## **9.2 Water Systems**

The information in this section of the reference ABWR DCD, including all subsections, tables, and figures, is incorporated by reference with the following departures and supplements:

**Figure 9.2-6b Turbine Building Cooling Water System Diagram**

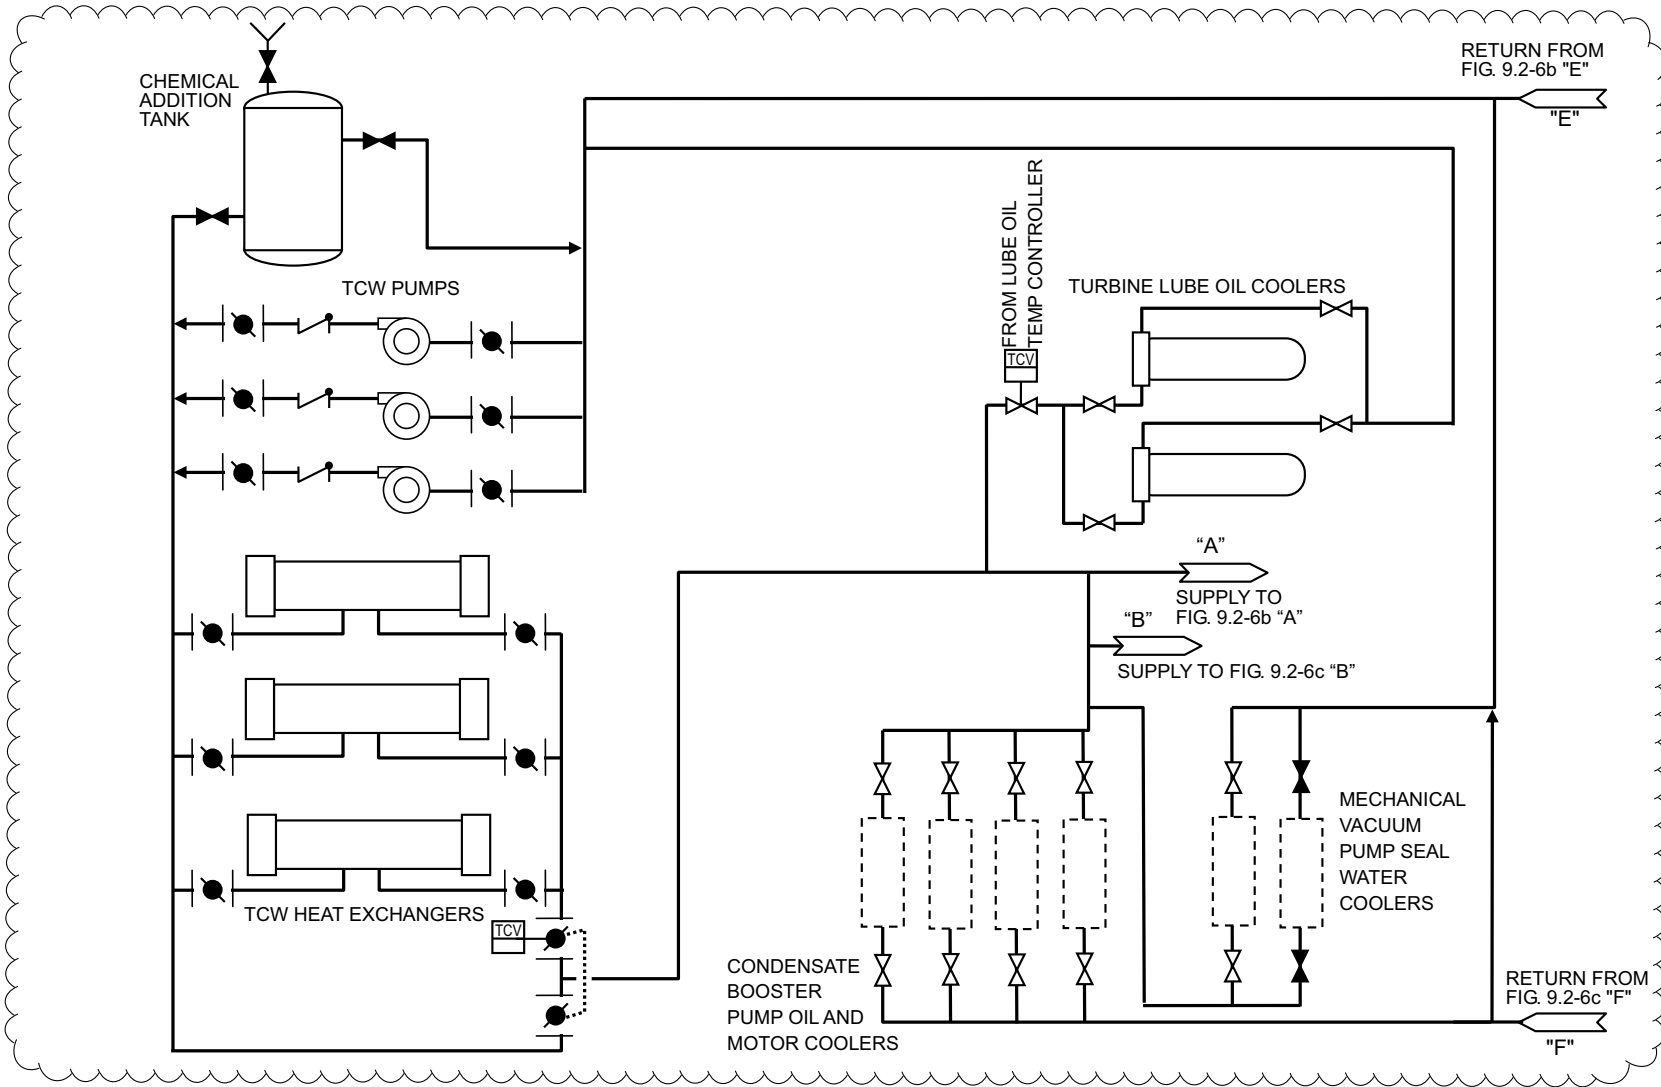
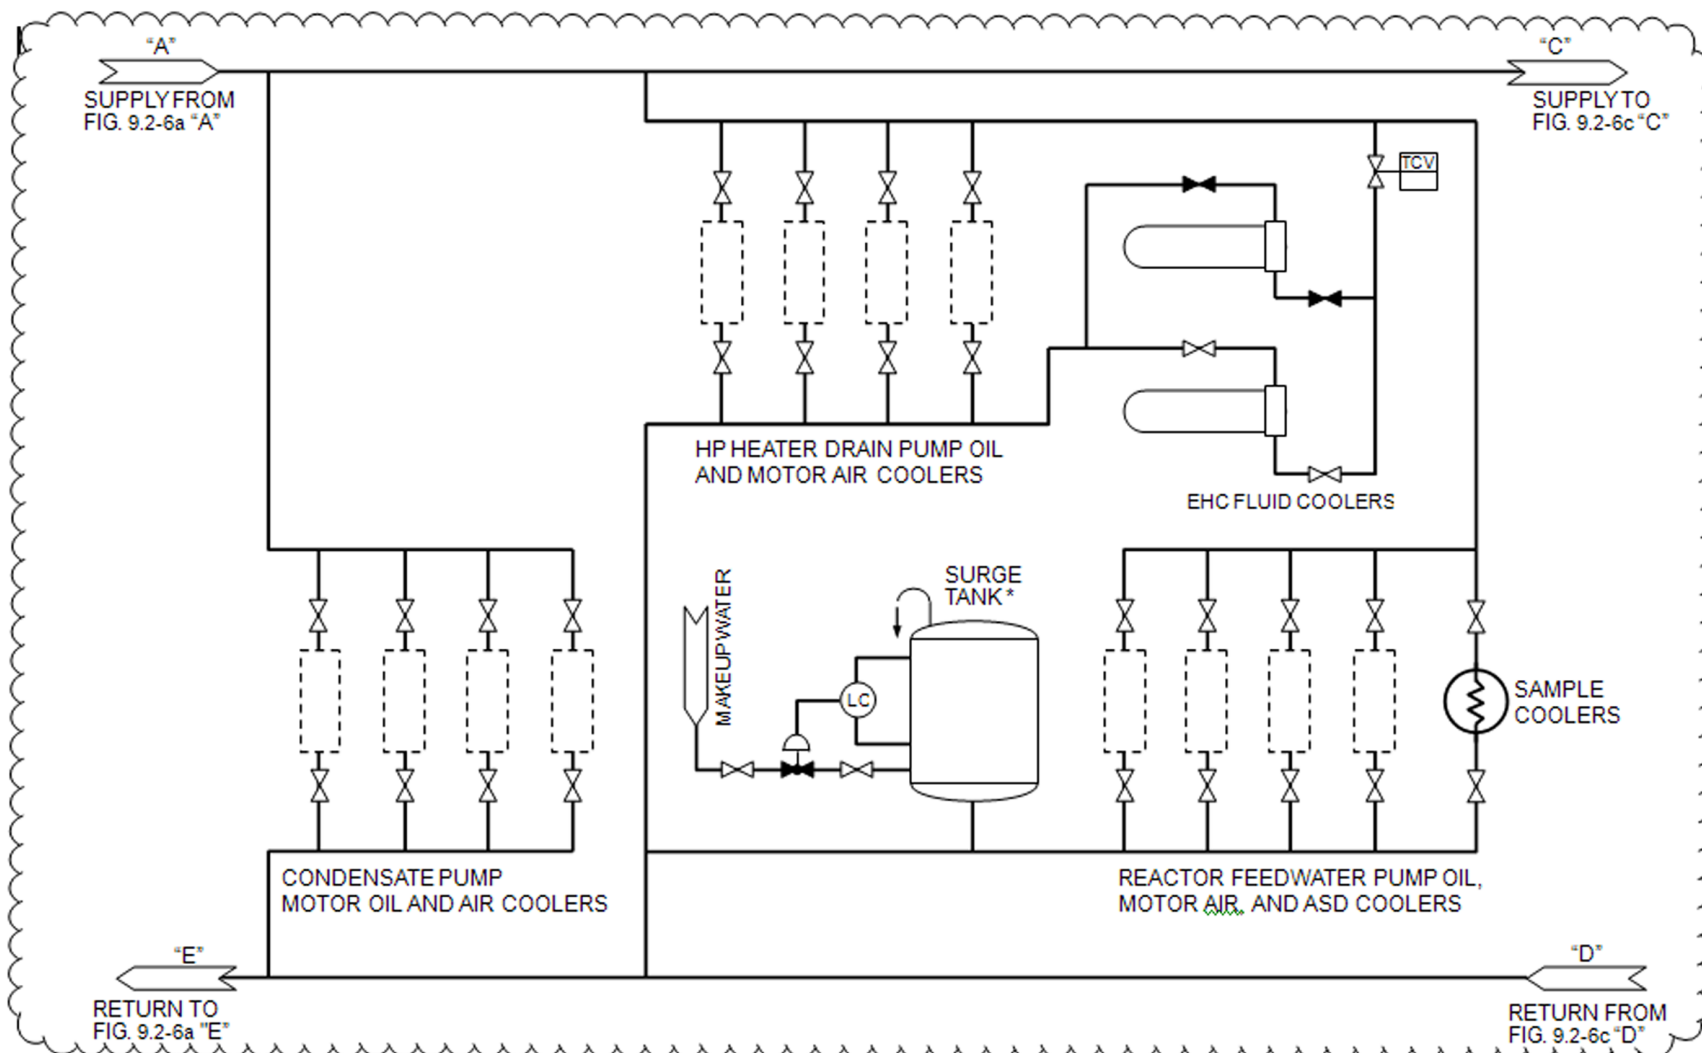
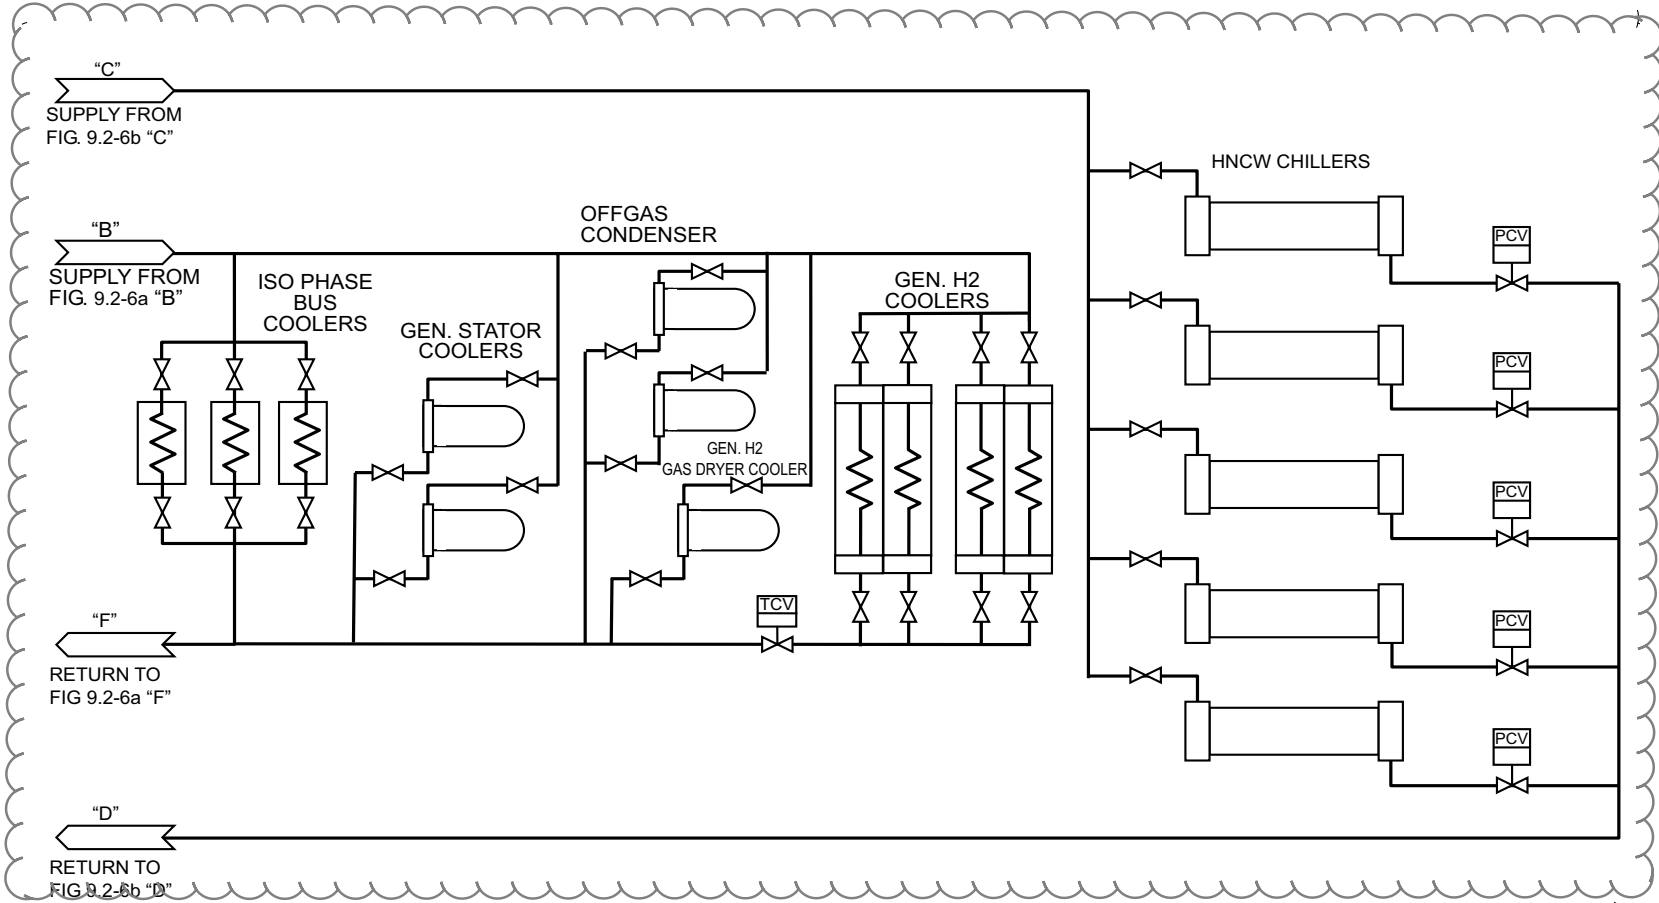
STP DEP 9.2-3 (Table 9.2-11, Figures 9.2-6a, 9.2-6b and 9.2-6c)

STD DEP Admin (Table 9.2-11, Figure 9.2-6b)

Figure 9.2-8 Turbine Building Service Water System

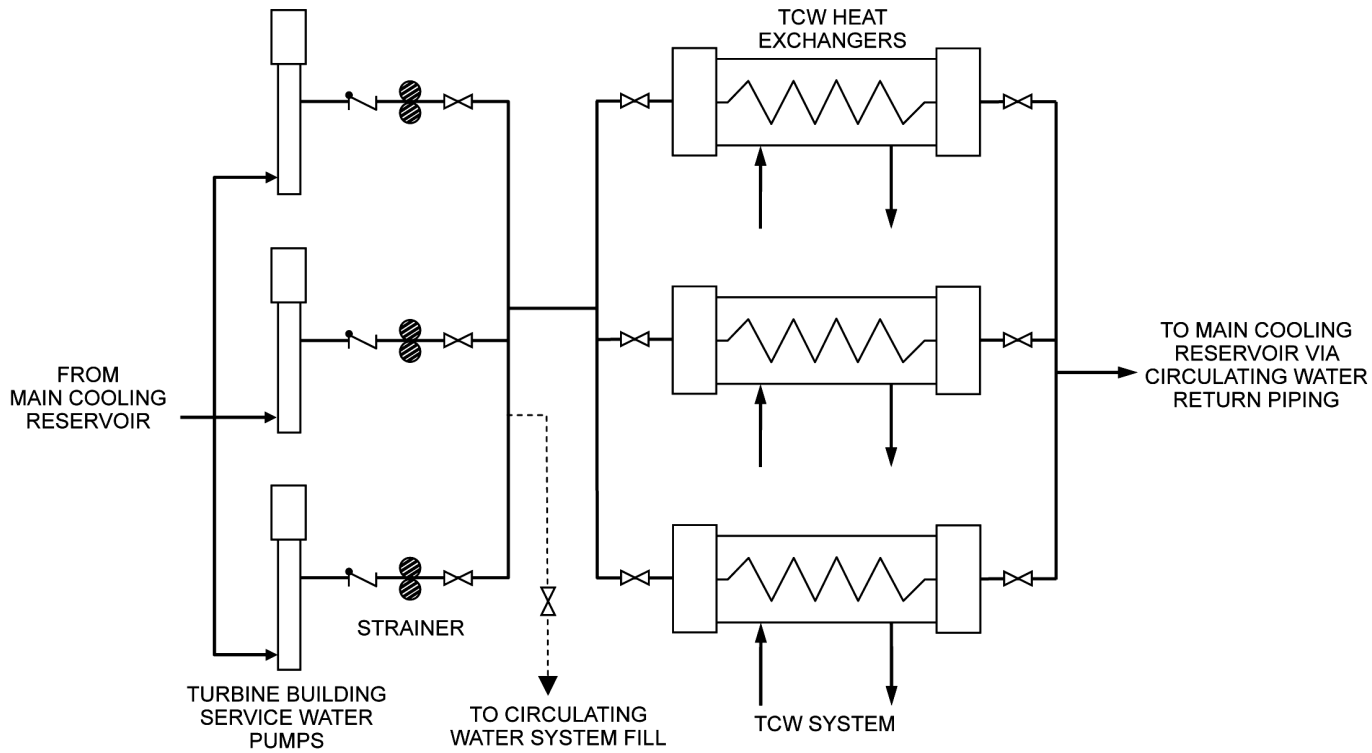
STP DEP 9.2-10 (Table 9.2-16, Figure 9.2-8)

The TSW system, illustrated in Figure 9.2-8 with site-specific design information, consists of three 50% capacity vertical wet pit pumps located in the circulating water intake structure. Two pumps are in operation during normal operation with one pump in standby.

Figure 9.2-9 Potable and Sanitary Water System (Sheet 1 of 2)

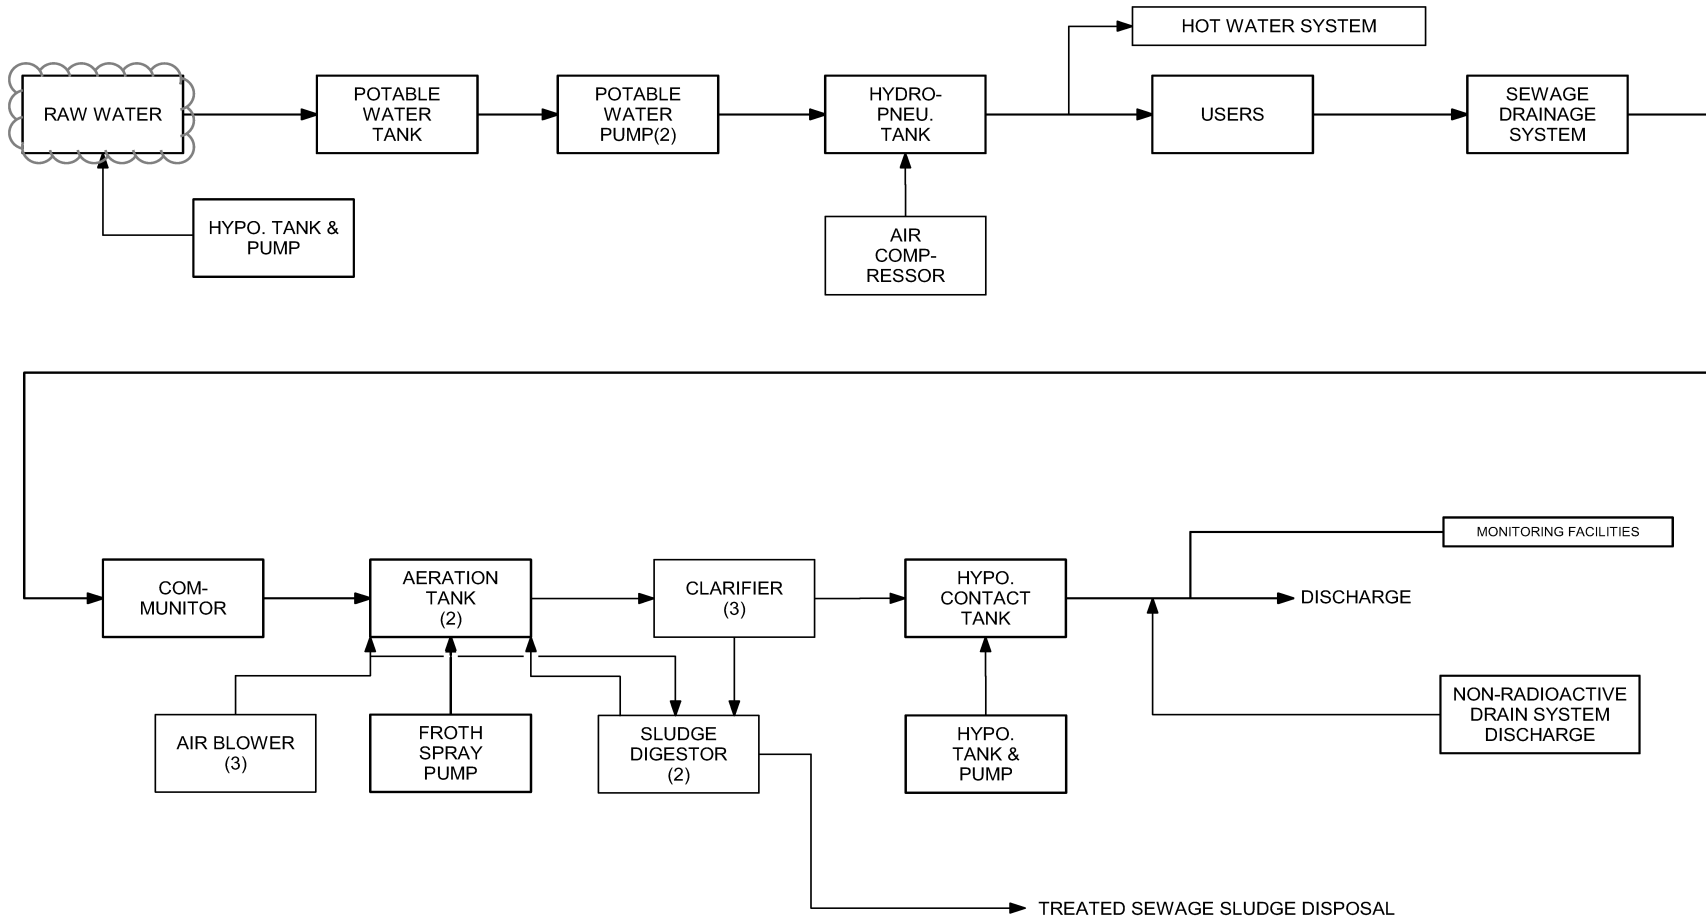
STP DEP 9.2-8 (Table 9.2-14 and Figure 9.2-9 Sheet 1 of 2)

- (1) *The PSW System is designed to provide to all buildings at STP 3 & 4 a minimum of ~~45 m<sup>3</sup>/h~~ 90 m<sup>3</sup>/h of potable water intermittently during peak demands.*

- (2) *Potable water will be supplied directly off of the well water system and is ~~filtered and~~ chemically treated to prevent harmful physiological effects on plant personnel.*

- (4) *The PSW System includes a sewage treatment system which treats sanitary waste for all four units at the STP site using the activated sludge biological treatment process. The aeration tanks are capable of receiving waste at a rate ~~between 45 m<sup>3</sup>/d and 185~~ of 1136 m<sup>3</sup>/d.*

Figure 9.2-10 Makeup Water Preparation System (Interface Requirements)

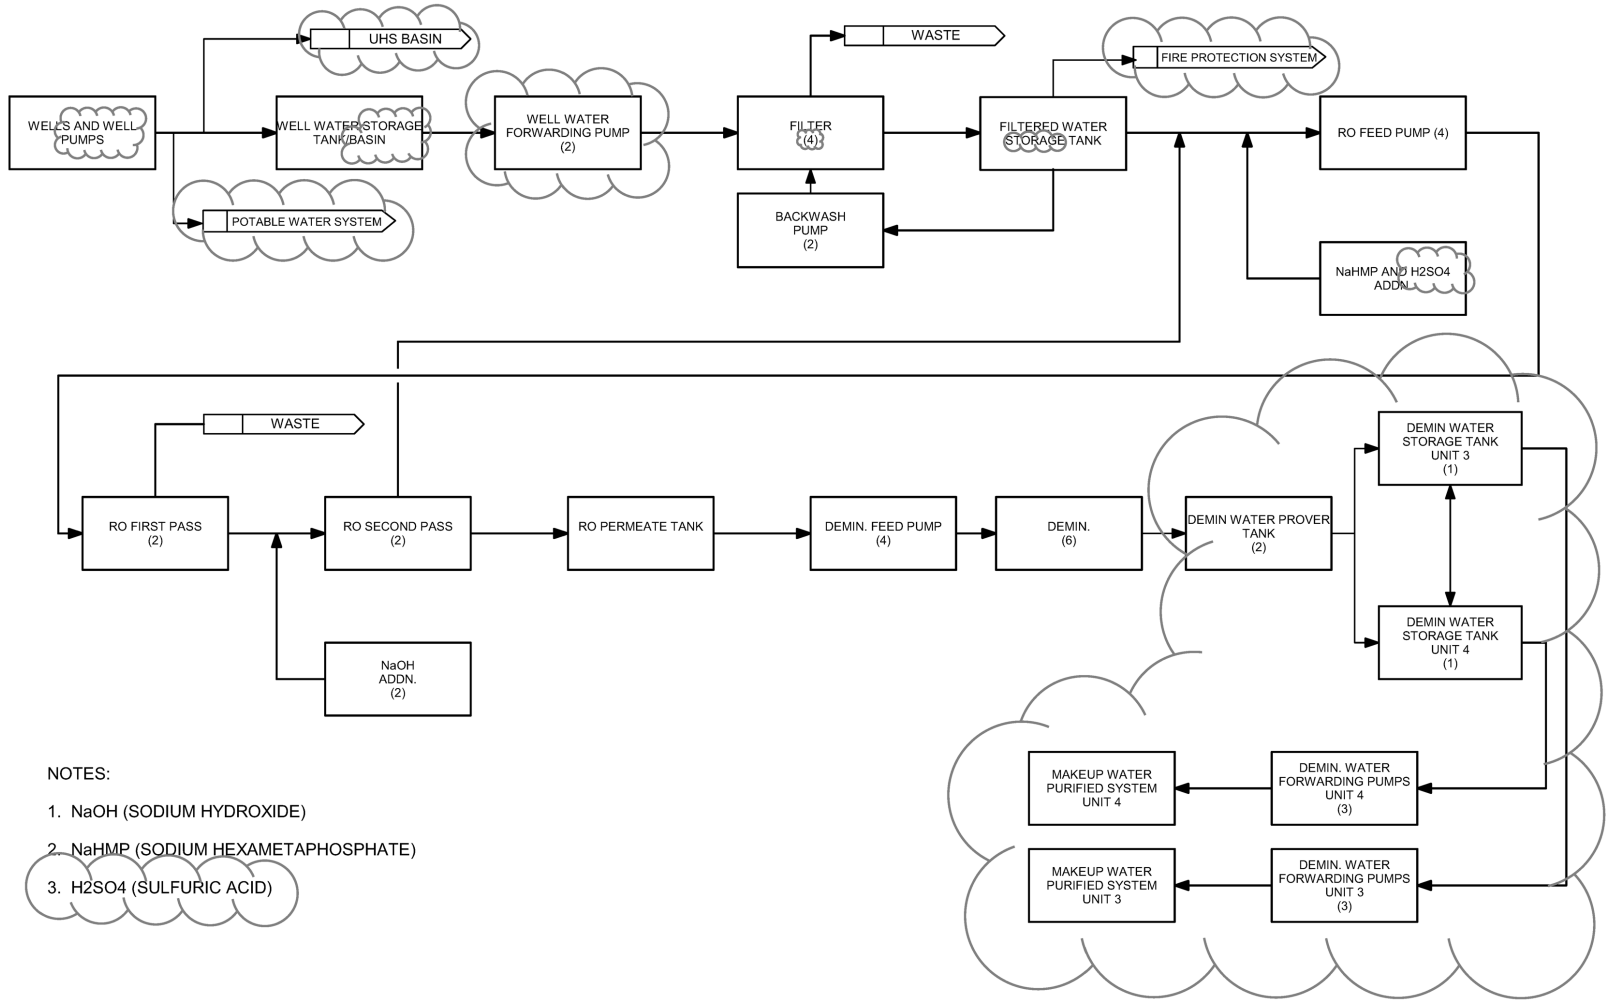
STP DEP 9.2-2 (Table 9.2-15, Figure 9.2-10)

The permanently installed system consists of wells, filters, RO modules, and demineralizers that prepare demineralized water from well water. The demineralized water is sent to storage tanks until it is needed. The components of the MWP system are shared components with the exception of the demineralizer water storage tanks, which are cross-connected to provide demineralized water to STP 3 & 4. The components of the MWP system are listed in Table 9.2-15 and the system block flow diagram is in Figure 9.2-10.
